OICA PROPOSAL FOR DRAFT AMENDMENTS TO REGULATION No. 83

This proposal has been prepared by the experts from OICA in order to amend the requirements of Regulation No. 83, to update the specifications for the proportional speed fan which can be used during testing of the vehicle on the chassis dynamometer.

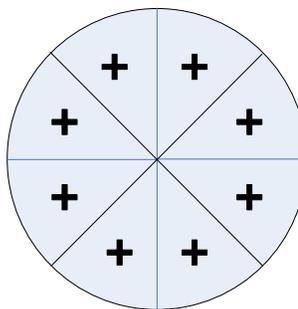
- (a) For blowers with rectangular outlets are located at the centre of each rectangle dividing the whole of the blower outlet into 9 areas (dividing both horizontal and vertical sides of the blower outlet into 3 equal parts).
- (b) For circular blower outlets, the outlet shall be divided into 8 equal arcs by vertical, horizontal and 45° lines. The measurement points lie on the radial centre line of each arc (22.5°) at a radius of two thirds of the total (as shown in the diagram below).

~~Each value at those points shall be within 10 per cent of the averaged value of~~

These measurements shall be made with no vehicle or other obstruction in front of the fan.

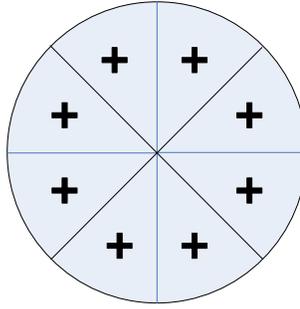
- (a) For blowers with rectangular outlets are located at the centre of each rectangle dividing the whole of the blower outlet into 9 areas (dividing both horizontal and vertical sides of the blower outlet into 3 equal parts).
- (b) For circular blower outlets, the outlet shall be divided into 8 equal arcs by vertical, horizontal and 45° lines. The measurement points lie on the radial centre line of each arc (22.5°) at a radius of two thirds of the total (as shown in the diagram below).

~~Each value at those points shall be within 10 per cent of the averaged value of themselves.~~

These measurements shall be made with no vehicle or other obstruction in front of the fan.

Air Speed Measurements with and Without vehicle installed (averages of 9 measurement points)

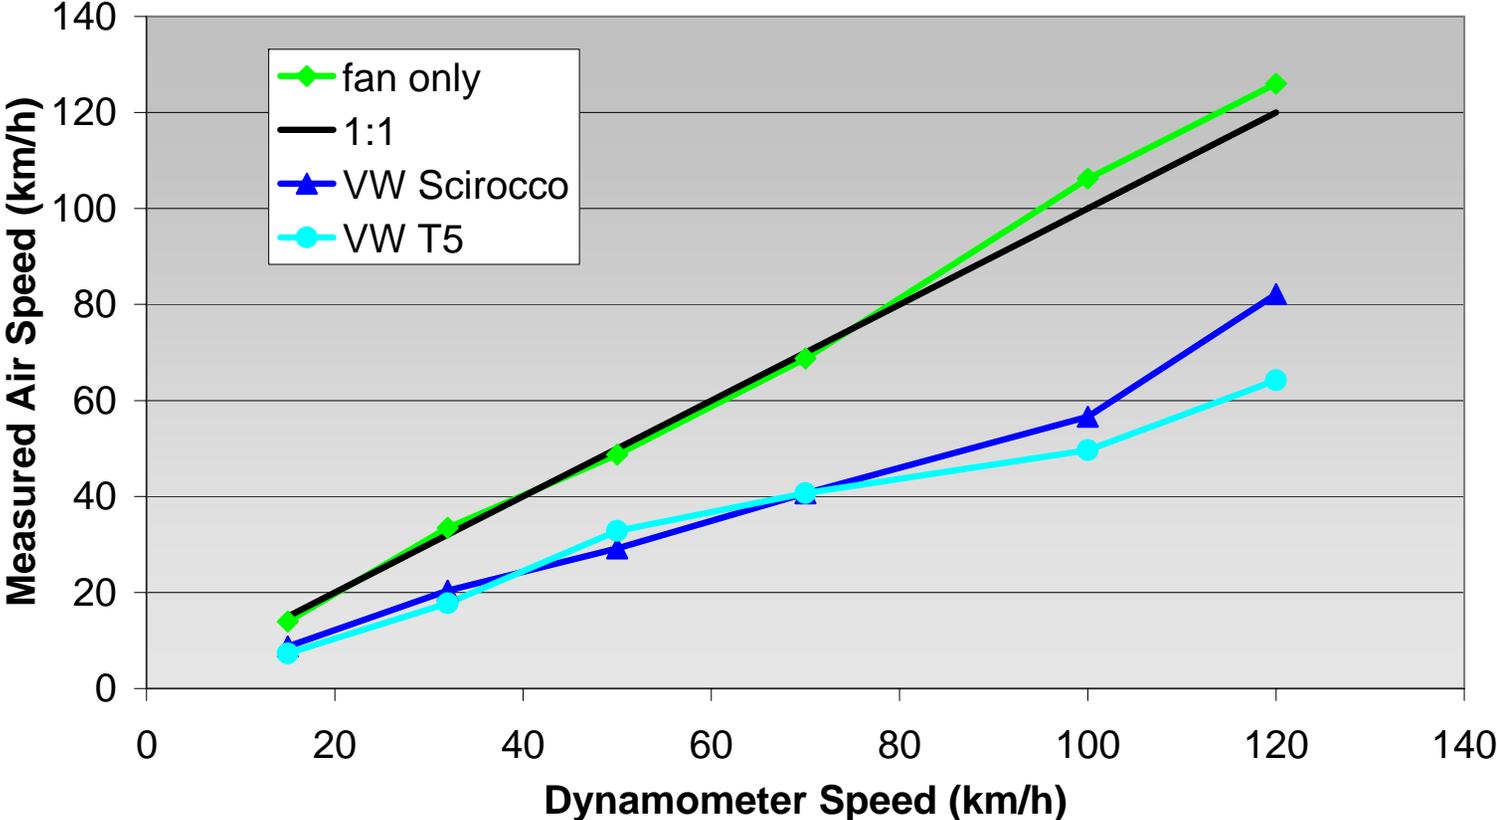
Should the measurements be made with or without a vehicle? The requirement is purely a specification of the fan suggesting that the “no car” measurements are correct, but the test is of course performed with a vehicle in place suggesting that the “car” measurements are correct. A comparison of “car” and “no car” measurements (see attachment 1) reveals however that due to the flow restriction caused by the vehicle, no meaningful measurements can be made with a vehicle installed.

OICA therefore proposes to add the statement that air flow measurements must be made with no vehicle installed in front of the fan.
